Office Action Summary	Application No.	Applicant(s)	
	10/549,501	UYTTERHAEGHE ET AL.	
	Examiner	Art Unit	
	ELIZABETH VOLZ	3781

DETAILED ACTION

Figure 5 (Smith et al.)

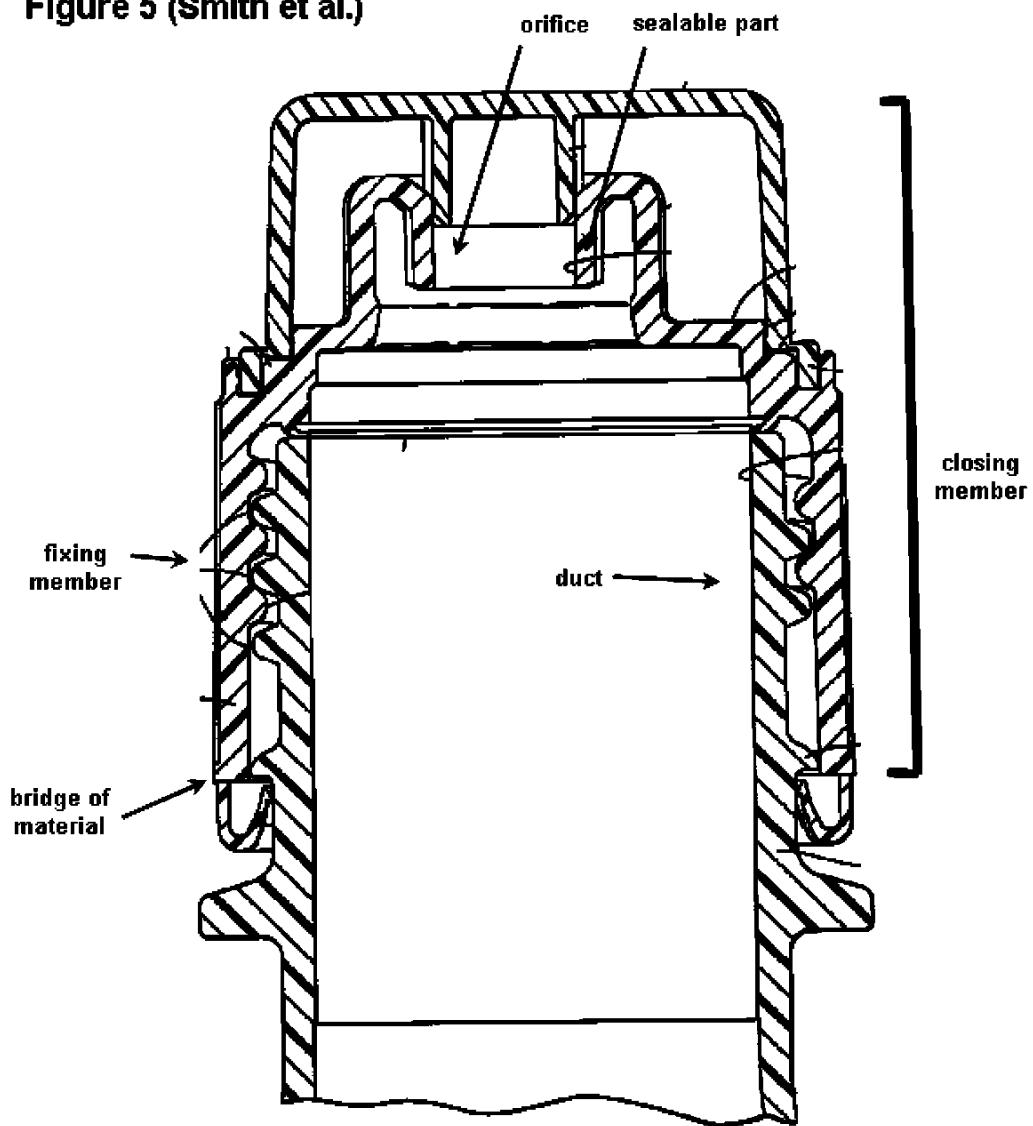
3. Regarding Claim 1, Smith et al. discloses a closure device formed as a single piece (Paragraph 16) by injection molding plastic material (Paragraph 39) and comprising: a fixing member (Figure 5 below) intended to cooperate with the reservoir opening (Figure 5) to form a sealed attachment, a dispensing duct (Figure 5 below) forming an outlet passage for the fluid product contained in the reservoir, said duct forming a dispensing orifice (Figure 5 below), a closing member (Figure 5 below) to close and seal said duct, said closing member being joined to the dispensing duct by at least one bridge of material (Figure 5 below) intended to be broken when the closing member is first removed, wherein said closing member comprises a sealable part (Figure 5 below) said sealable part, before sealing, leaving the dispensing orifice clear (Figure 8) before the first removal of the closing member and, after sealing, closing the dispensing orifice in sealed manner (Figure 5).

4. Regarding Claim 3, Smith et al. discloses a sealable part (Figure 5 above) which is deformable and can be welded to itself (Figure 5).
5. Regarding Claim 11, Smith et al. discloses a duct (Figure 5 above) and a closing member (Figure 5 above) are provided with snap-fit means 29 (Figure 5) intended to cooperate after the breaking of said at least one bridge of material (Figure 5 above).

6. Regarding Claim 12, Smith et al. discloses a snap-fit means 29 (Figure 5) which forms a sealing means closing the duct (Figure 5).

7. Regarding Claim 14, Smith et al. discloses leaving the dispensing orifice (Figure 5 above) clear (Figure 8) and closing the dispensing orifice in a sealed manner each represent a separate status for the sealing member when the bridge is still intact.

8. Regarding Claim 15, Smith et al. discloses a sealable part (Figure 5 above) which provides a structure (Figure 5) in which the fluid product reservoir is able to be filled when the closing member is attached to the fluid product reservoir.
